NO.	DESCRIPTION	DATE
REVISIONS		
PROGRESS ENERGY CORPORATION CRYSTAL RIVER, FLORIDA CRYSTAL RIVER PLANT 855,000 KW UNIT NO. 3		
ELECTRICAL		ICS
MAIN CONTROL BOARD INTEG. CONT. SYSTEM ASSY.		
READING PERM.	DRAFTING	APPROVED
MADE	CHECKED	APP
DATE	SCALE	SIZE
	3/4	5500
	D-201-141	8
	E-201-141	10

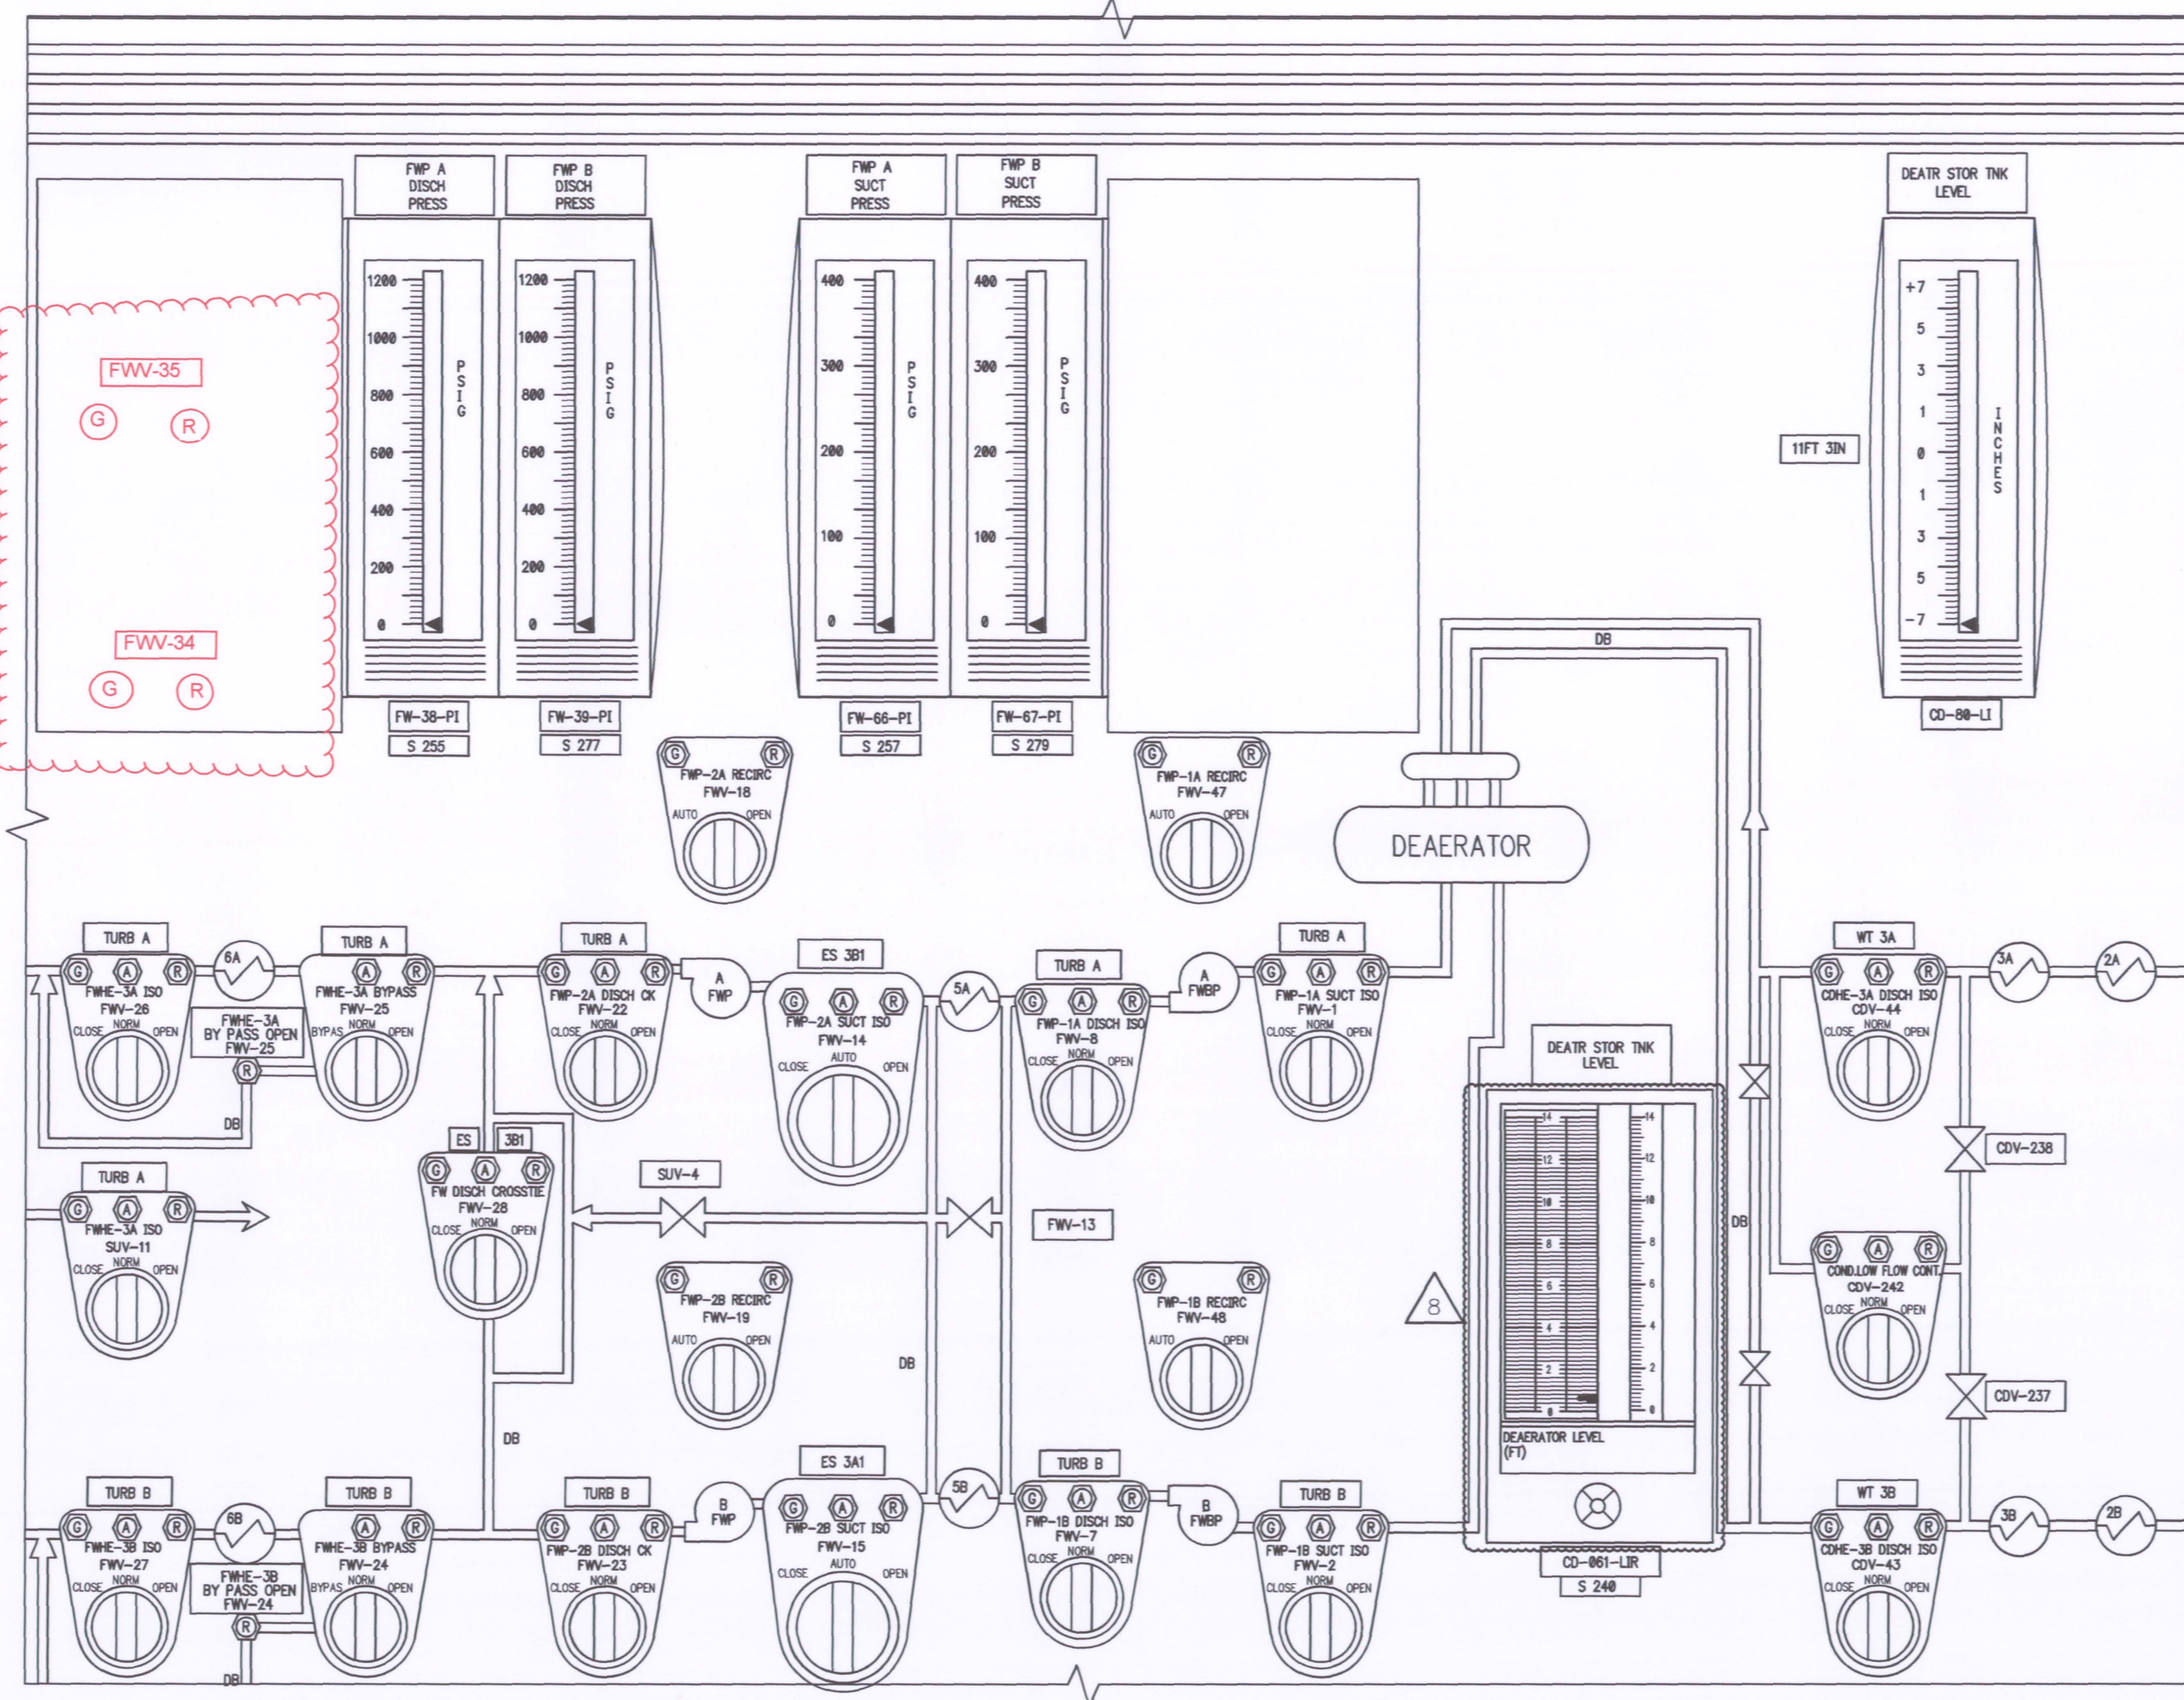
Relocation of FWW-34 and FWW-35 indicators.
